Date 08.01.10	Ref. No. 09TV102R1	Model KDL-32D3000, KDL-32D3010	RASC BC
Subject Vertical Lines [REVISION 1]			IRIS 138A

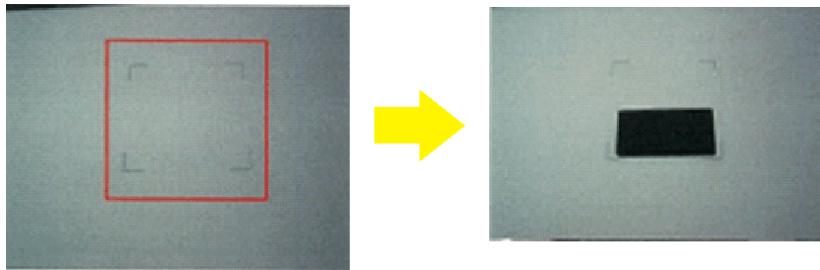
3. There is a marker on the place where the black cushion was. At the bottom of this marker, pile two pieces of "Himeron" tape to a total height of 1 mm.

4. Paste a piece of "Thermal Sheet" on the "Himeron".
